NSLPP MEETING HELD ON 07/05/2025

ADDRESS/WARD: 1B Pine Street, Cammeray

APPLICATION NO: DA 40/21/3

PROPOSAL: Section 4.55(2) modifications for various changes to a deferred commencement consent for a two storey detached dwelling

Figure 15: Rear balcony, Deletion of external staircase and Changes to the internal staircase

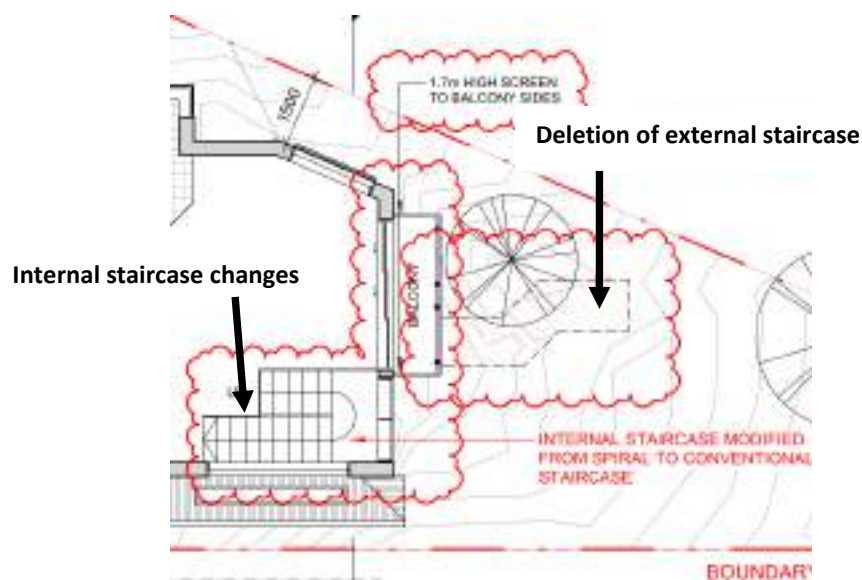
It is considered that the modified design is generally acceptable given that the proposed first floor balcony is 1m deep and is unlikely to cause an unreasonable level of privacy impacts with the proposed installation of privacy screens on the edges of the balcony.

AA1(d) – Internal layout changes

It is considered that the internal layout has been appropriately modified having regard to the proposed design modifications.

Figure 16: Brick wall adjacent to driveway of 497 Miler Street and 1A Pine Street

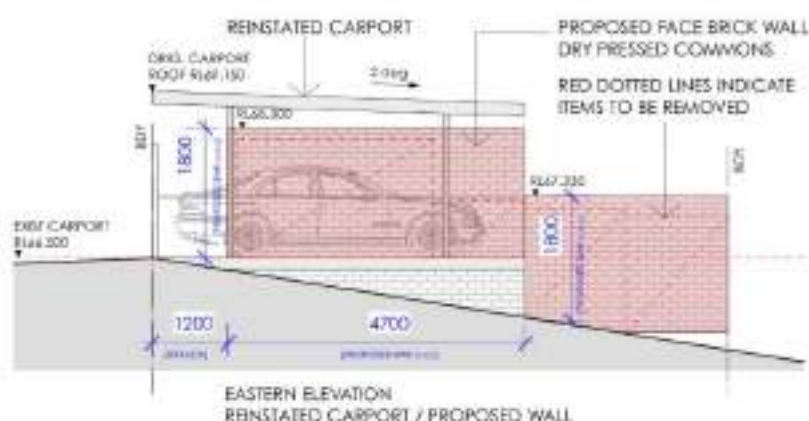
Condition AA3 (c) – Brick wall adjacent to the driveway of No. 497 Miller Street, No. 1A Pine Street

The applicant has submitted architectural drawing (Drawing numbered AR-DA-7000 Rev 2) demonstrating compliance with the requirements of Condition AA3 (c).

Figure 17: Roof treatment

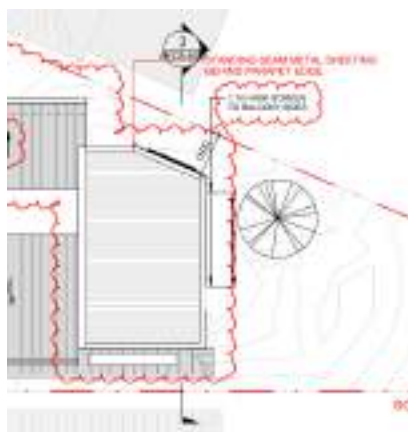
Condition AA3 (d) – Replacement of first floor concrete flat roof by sloping colorbond roof

The applicant has submitted architectural drawing (Drawing numbered AR-DA-2002 Rev 2) showing the installation of standing seam metal sheeting behind the parapet edge at the rear of the proposed dwelling. No objection is raised to this aspect of the proposal given that the intent of the original condition, i.e. not to facilitate the use of the roof as a terrace with a concrete roof slab, is met.

Figure 18 : Mid Winter shadow diagrams

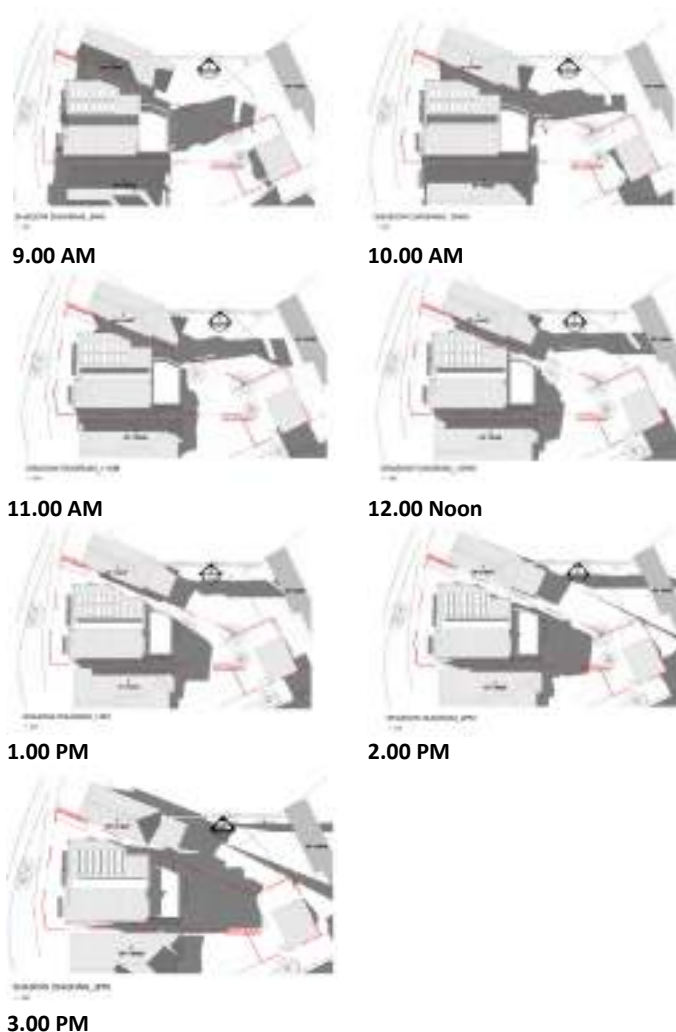
An examination of the shadow diagram has revealed that the additional shadow caused by this breach would fall primarily on the roof of the adjoining dwelling at No. 491 Miller Street resulting no material change in terms of solar access.

Whilst the proposal would cause non-complying shadowing on the adjoining property at No.491 Miller Street, the impacts are considered to be acceptable having regard to the site circumstances as detailed above.

There would be no material shadowing impacts on the other adjoining properties between 9am and 3pm during mid winter (21 June).

SHEET NUMBER:
AR-DA-2000

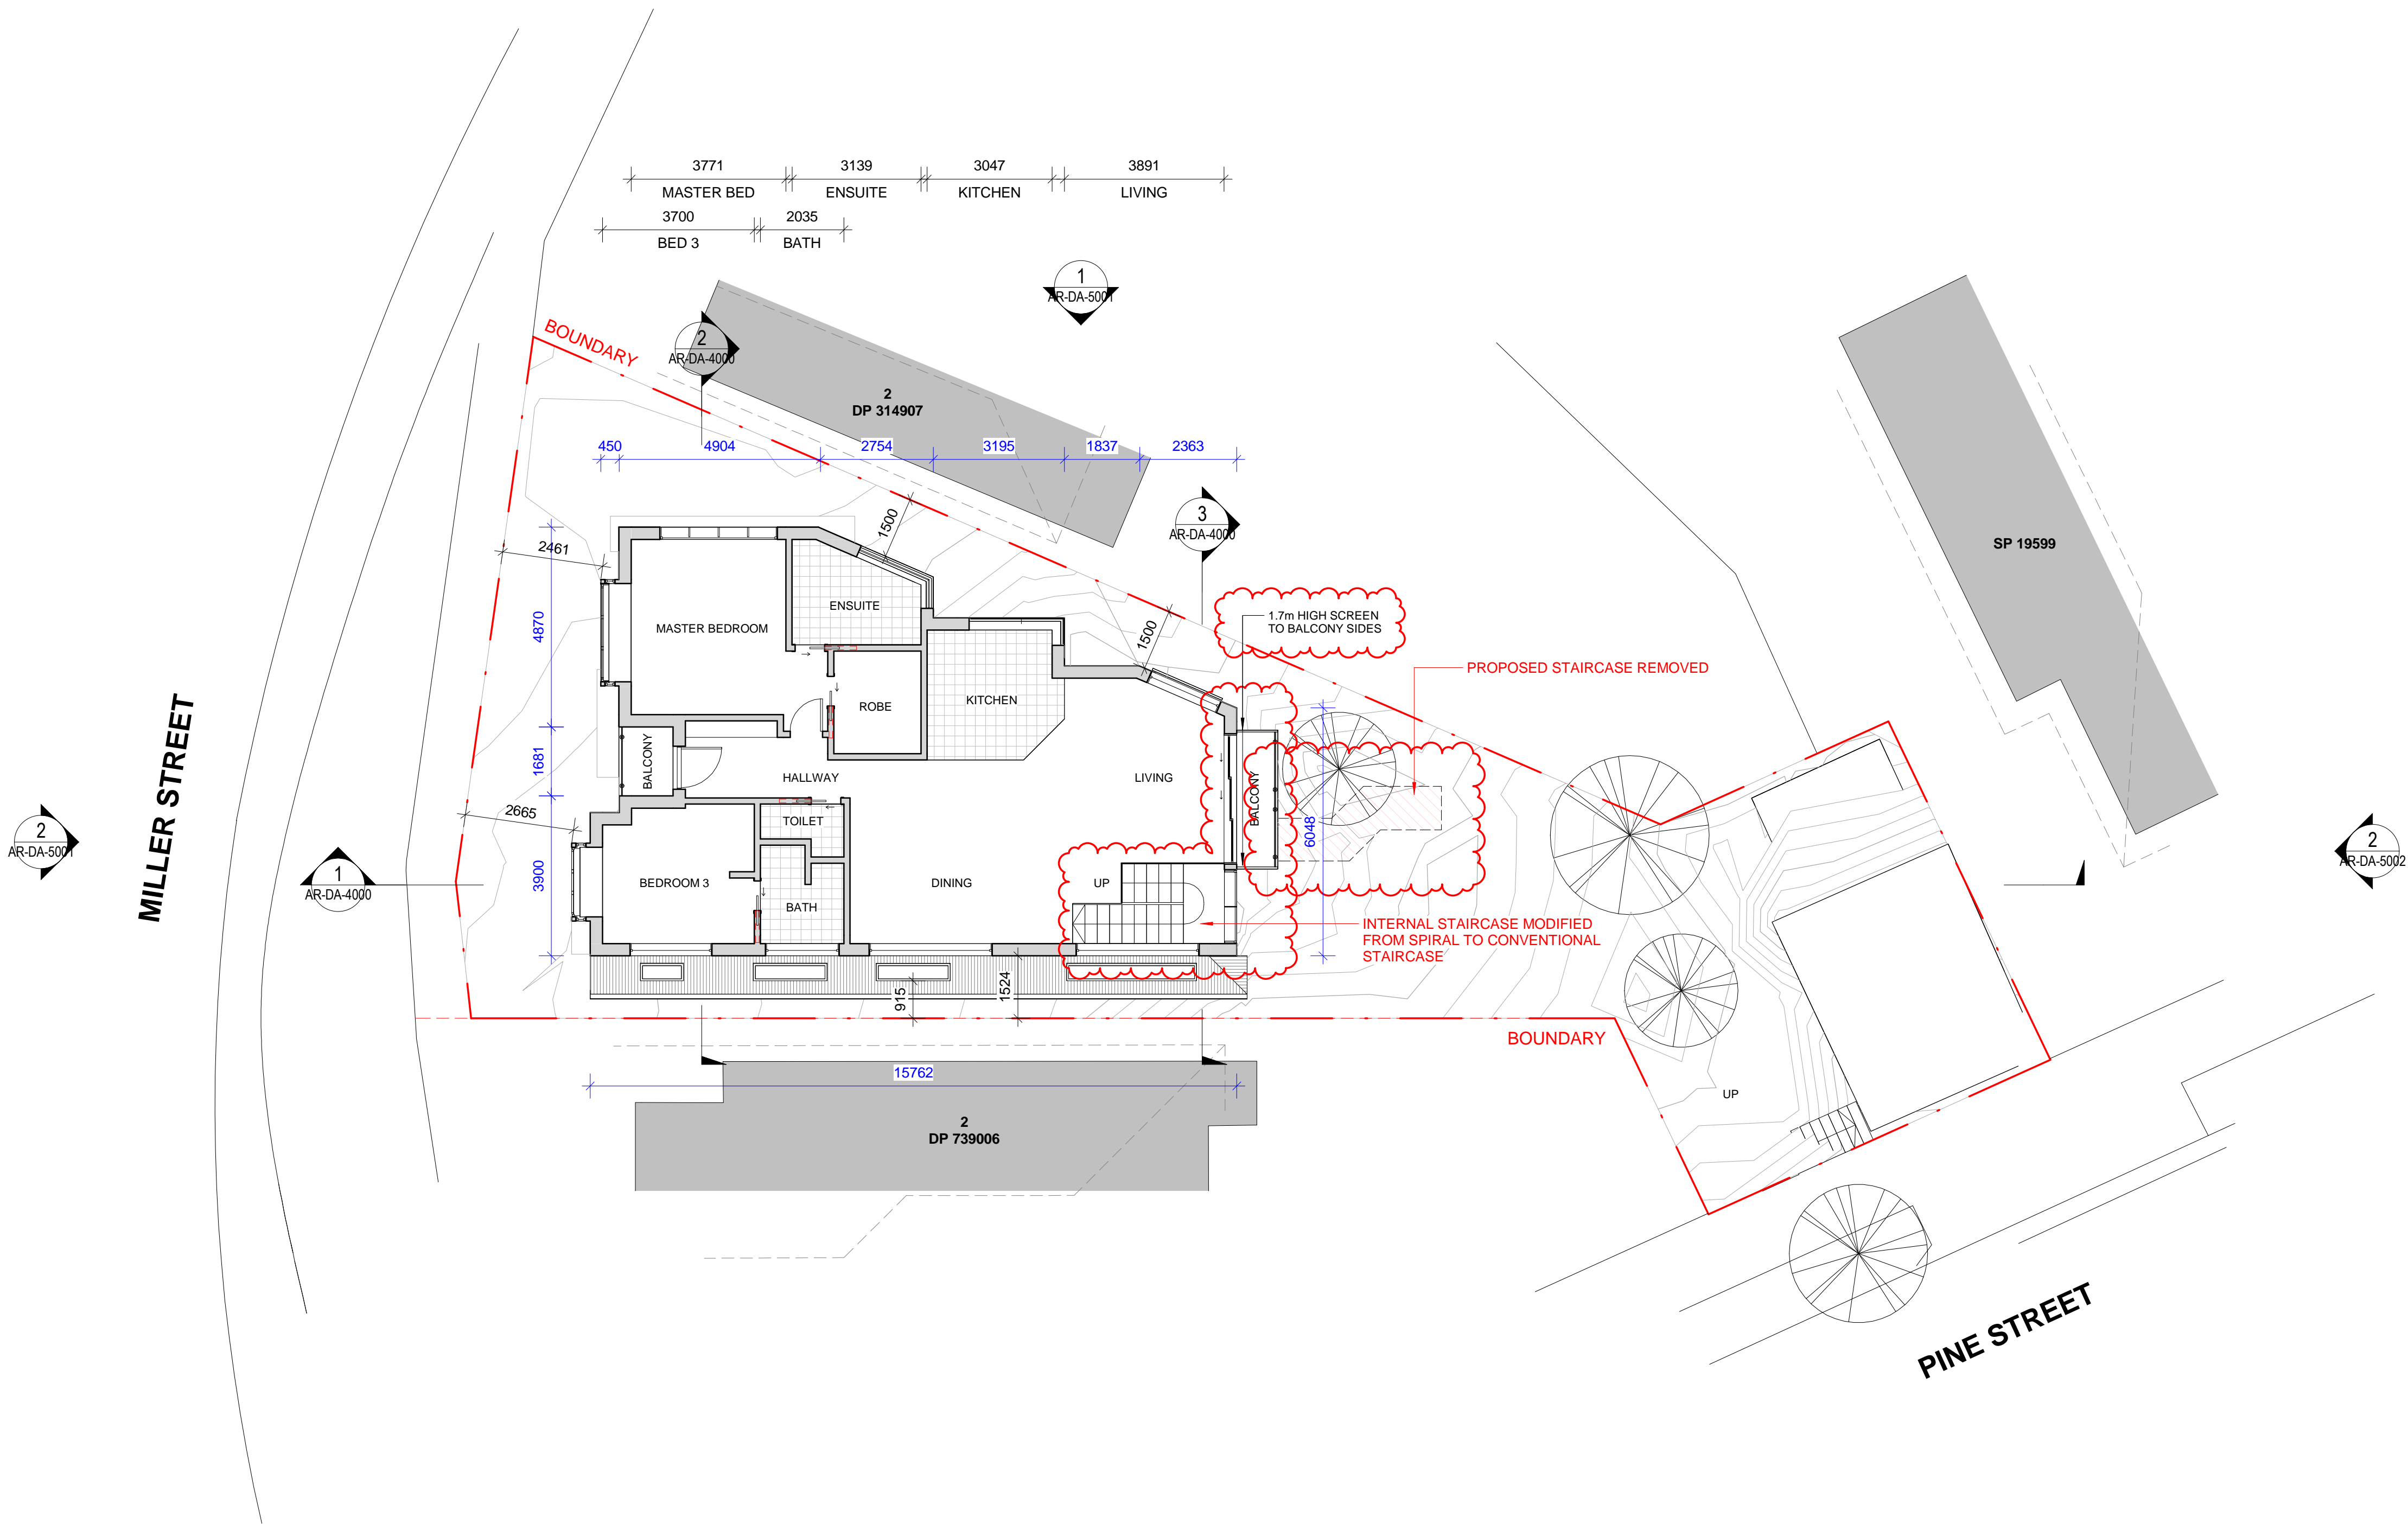
It is noted that the submitted ground floor plan (Drawing numbered AR-DA-2000 Rev 2) contains an annotation “Proposed planting bamboo screening” at the rear of the common property boundary with No 491 Miller Street. It is recommended that a condition be imposed requiring the deletion of this annotation to ensure clarity (**Condition C22**).

As indicated earlier in this report, a condition be imposed requiring the deletion of this annotation "Proposed planting bamboo screening" on the ground floor plan (Drawing numbered AR-DA-2000 Rev 2) to ensure clarity (**Condition C22**).
